CERTIFICATE OF APPROPRIATENESS

Property: 210 Marshall Street, Lot 7, Block 8, Westmoreland Subdivision. The property includes a contributing 4,614 square foot two-story multi-family residence situated on a 6,250 square foot interior lot with a contributing secondary structure located in the rear portion of the property.

Proposal: Alteration—Applicant proposes to do the following to the contributing secondary structure located on the rear portion of the property:

Rendering of Planned Restoration/Alterations

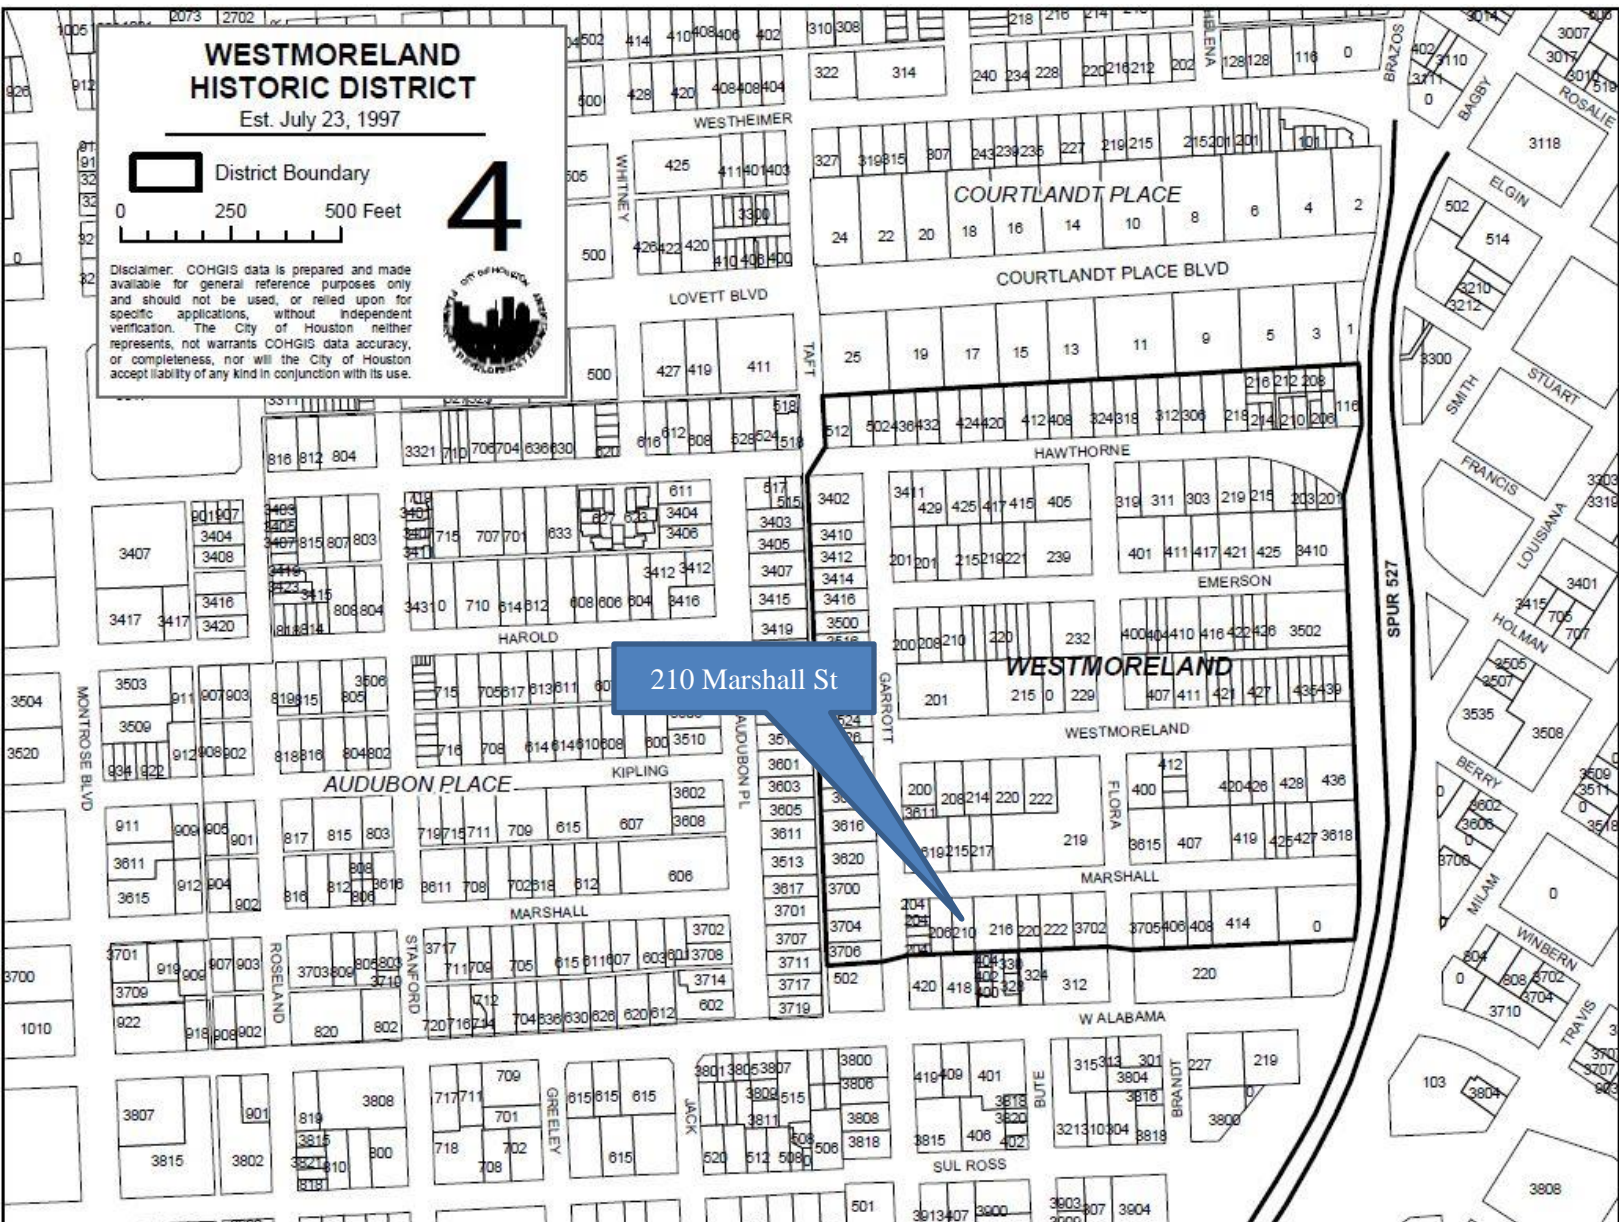
Roof pitch to change
